Access Compliance Report Public Rights-of-Way (Curb Ramps)

Main Street: S_CHURCH_ST		Cross Street: BOND_AVE		Location:	SW
ADA ID: RPAT211020091515	Ramp Type:Type 1 - Perpendicular Diagonal Initial Pass/Fail: Pass		Overall Compliance: No	Severity Score:	10
Codes/Mitigation Info/Possible Solution			Field Measurements/Component Compliance

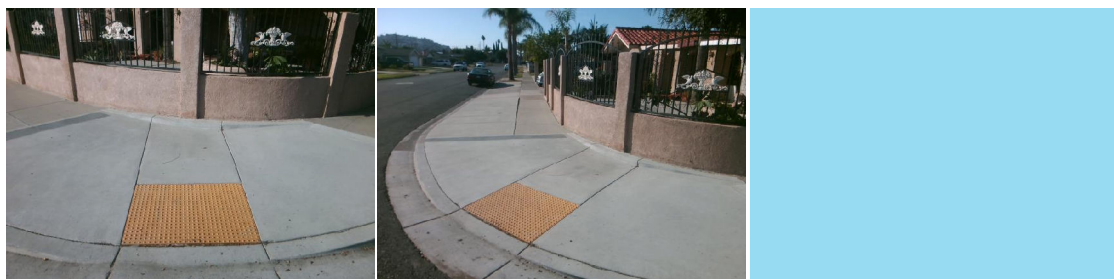
R304.2.2, R304.2.1, R304.5.4, STD 1115

Remove & Replace Curb Ramp With Two New Directional Ramps or Equivalent. Remove & Replace Gutter.
